Addendum to:

**Corrective Action Decision
Document/Corrective Action
Plan (CADD/CAP) for the
Subsurface Corrective Action
Unit 447 Shoal, Nevada, Site**

July 2019

Figure 5-31. Revised Contaminant and Compliance Boundaries, Shoal, Nevada, Site

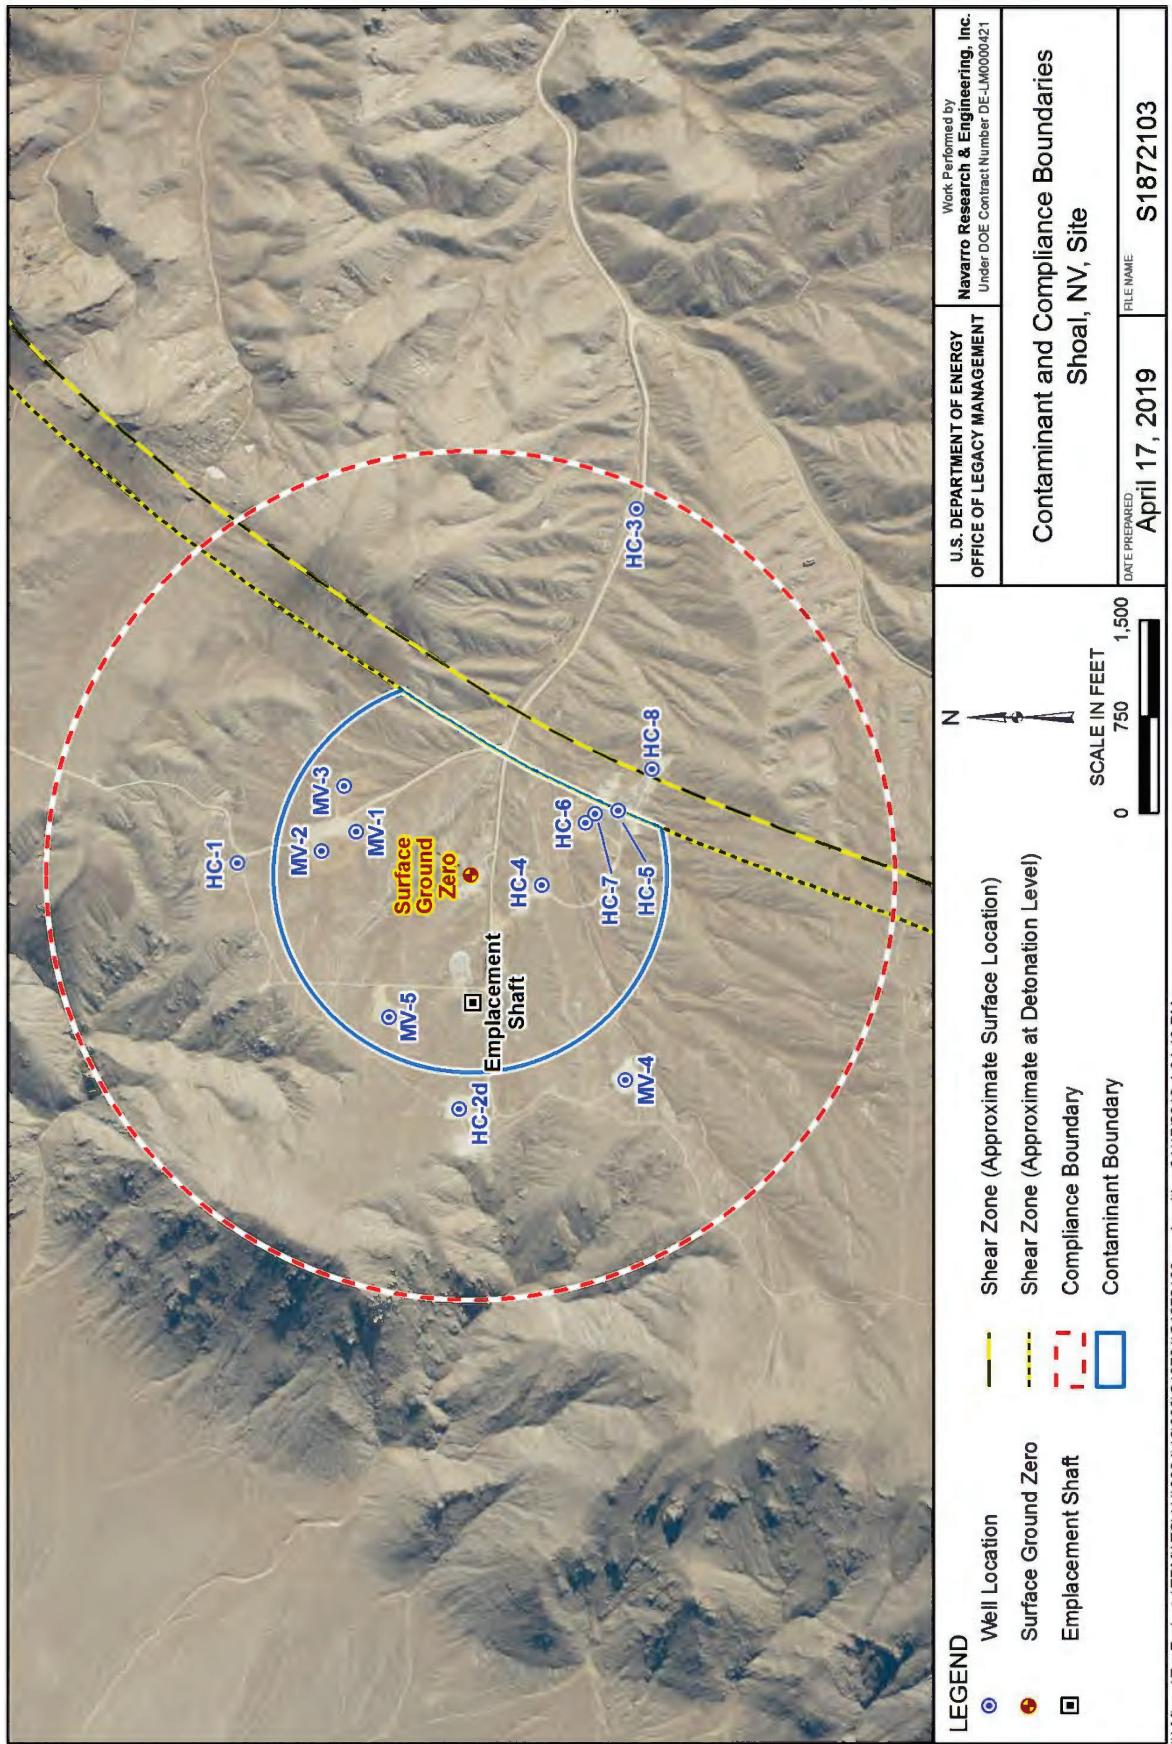
Groundwater elevations observed at wells MV-1, MV-2, and MV-3 did not validate the predominant horizontal flow direction predicted by the modeled realizations; however, hydraulic conductivity data from aquifer tests on these wells fell within the inner 95% of the hydraulic conductivity distribution used in the numerical model. This led to conclusions that the overall range of the hydraulic conductivity values used in the numerical model was reasonable, and the field observations at the three wells validate the range of hydraulic conductivity values selected for the multiple model realizations. Aquifer test data from the wells (MV-4, MV-5, and HC-2d) installed in 2014 also fall within the hydraulic conductivity distribution used in the numerical model and are slightly lower than the hydraulic conductivities obtained from the 2006 MV wells (Figure 4-30). These data reviewed with historical aquifer test data from other wells onsite support the extent, though not the direction, of the numerical model-predicted contaminant boundary. Given that water levels in site wells on the detonation side of the shear zone continue to rise and at differing rates, a prevailing horizontal flow direction cannot be identified at this time. It is also possible that the horizontal gradient will continue to vary over time and a stable flow direction will never be obtained. To account for these uncertainties, LM proposes a simplified yet conservative approach that assumes groundwater flow could occur in any direction from the detonation zone. This approach treats the contaminant boundary as a cylindrical surface that encompasses the contaminant volume. The lateral extent of the cylinder is based on the distance that encompasses 95% of the model realizations of contaminant transport, the same as the original modeled contaminant boundary except extended in all directions. The cylinder is truncated to the east at depth by the low-permeability shear zone that is a barrier to groundwater flow (Figure 5-31). Figure 4-30 presents the PDF of hydraulic conductivity values used for the numerical model with hydraulic conductivities from wells installed in 2006 (MV-1, MV-2, and MV-3) and wells installed in 2014 (MV-4, MV-5, and HC-2d).

The compliance boundary presented in the CADD/CAP matches the outer perimeter of the numerical model-predicted contaminant boundary. LM proposes to separate these boundaries and expand the compliance boundary so it coincides with the subsurface use-restriction boundary. The revised compliance boundary shall extend a horizontal distance of 3300 ft from SGZ (Figure 5-31) to accommodate uncertainties associated with the transient nature of the groundwater flow system and account for any potentially varying lateral flow directions. The objective of the compliance boundary has not changed. Figure 5-31 shows the revised contaminant boundary and compliance boundary for the site.
